**LEBANON PLANNING BOARD
NOVEMBER 21, 2022 - 6:30 PM
COUNCIL CHAMBERS, CITY HALL OR
REMOTE VIA VIRTUAL PLATFORM
LEBANONNH.GOV/LIVE**

**Agenda
Planning Board
November 21, 2022**

Staff Memorandum – PB2022-43-EXT

Site Plan Review for proposed additions to existing ice rink

SITE GRADING, DRAINAGE & UTILITY PLAN
SCALE: 1"=20'

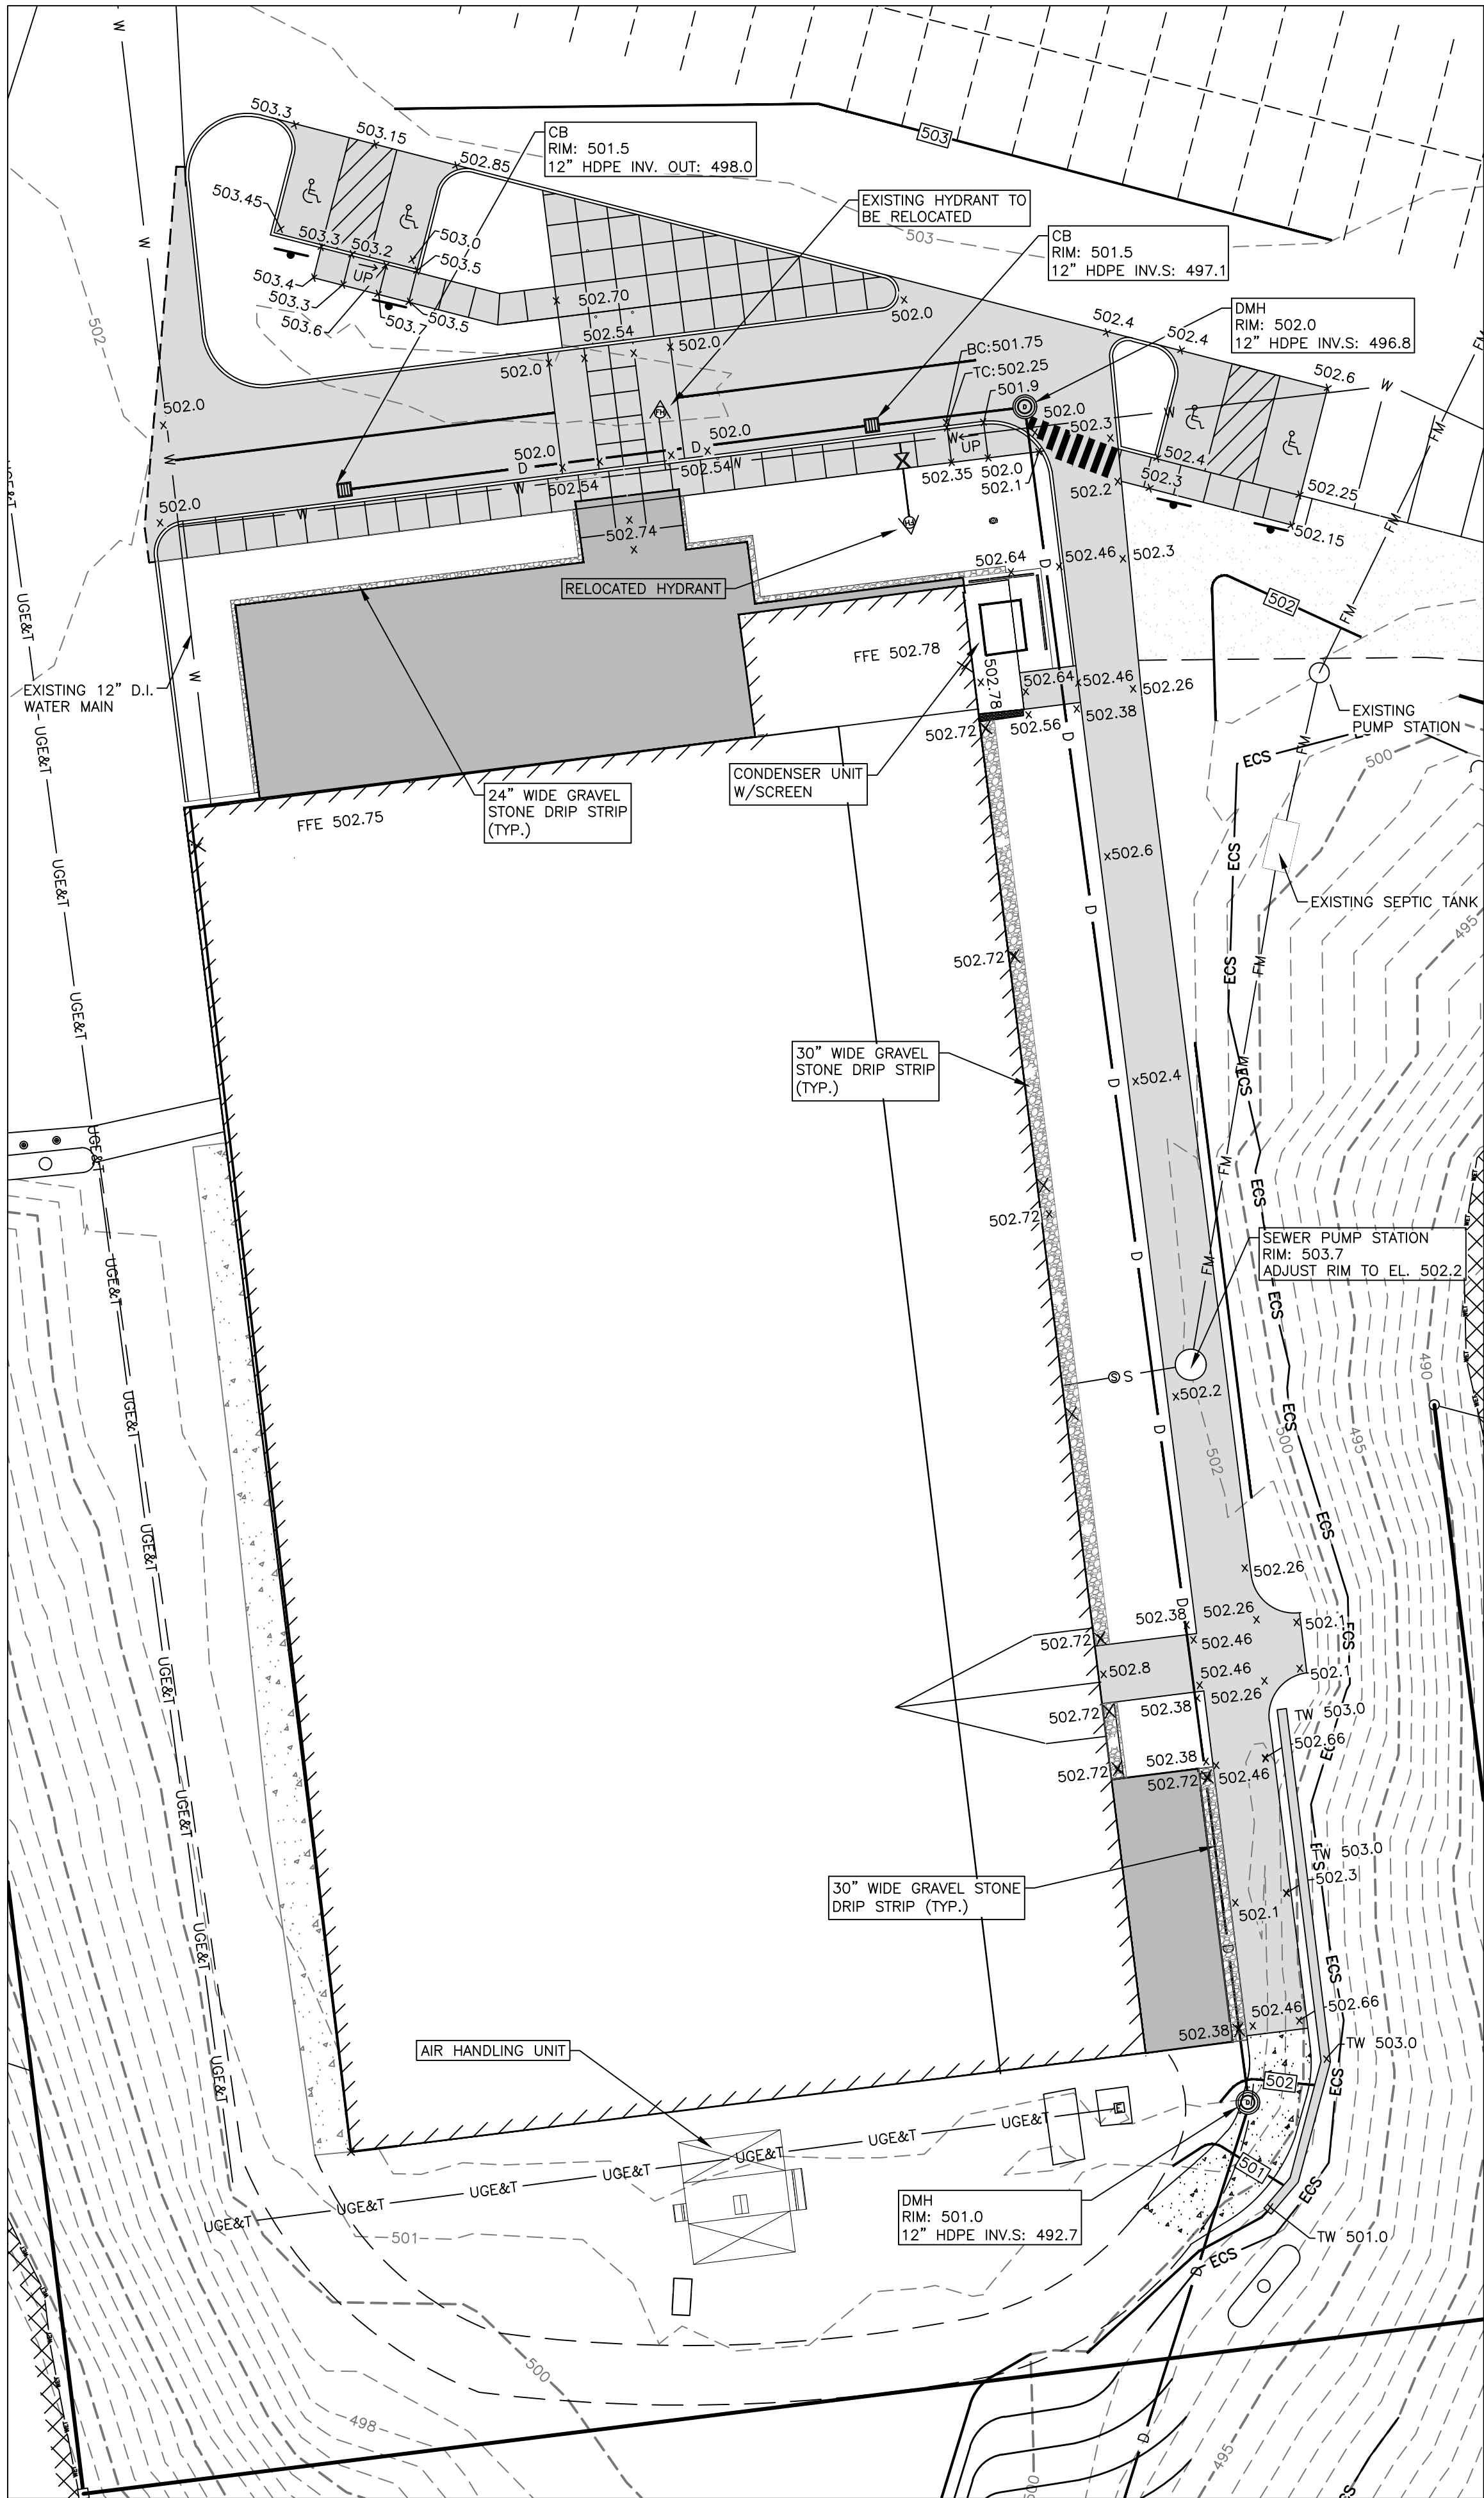
2. Given the nature of the native soils within the placement area of the proposed infiltration basin, it is recommended that the applicant provide a reinforced overflow weir and detail of how the weir reinforcing materials would be constructed. This may also apply to the forebay overflow weir. It is understood that the drainage model shows no overflow to the weir, but staff still recommends that reinforcing materials are installed.

3. Confirm that the proposed relocated hydrant location is properly spaced from the building/proposed building addition.
4. Actual measured saturated hydraulic conductivity test results, as well as estimated seasonal high water table elevation shall be provided to DPW for review prior to construction. The applicant should also share any intent to add soil amendments to the site if required/applicable, as well as design details.

7. Actual measured saturated hydraulic conductivity test results, as well as estimated seasonal high water table elevation shall be provided to DPW for review prior to construction. The applicant should also share any intent to add soil amendments to the site if required/applicable, as well as design details.

DETAIL OF OUTLET CONTROL MH
DMH-10
NOT TO SCALE

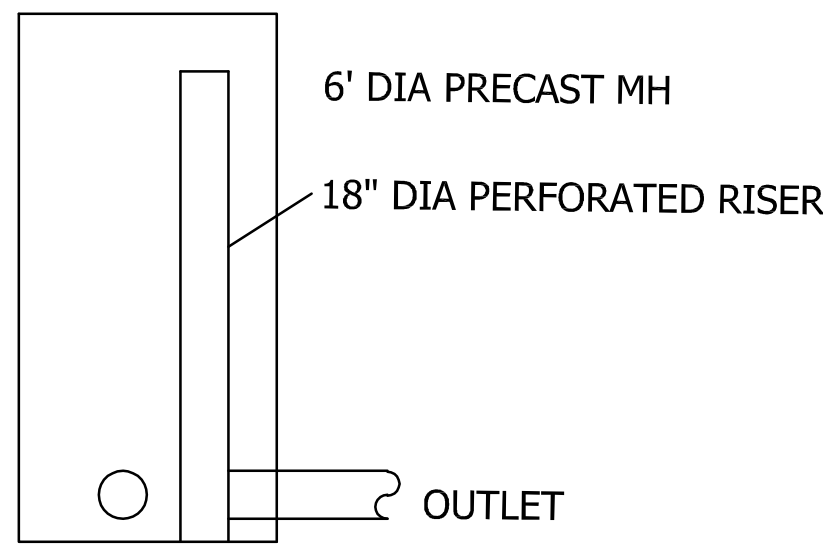
5. Outlet control. The main system outlet control will be in DMH-10. The control device will be an 18" totally perforated pipe. A schematic is shown on Sheet C-5.
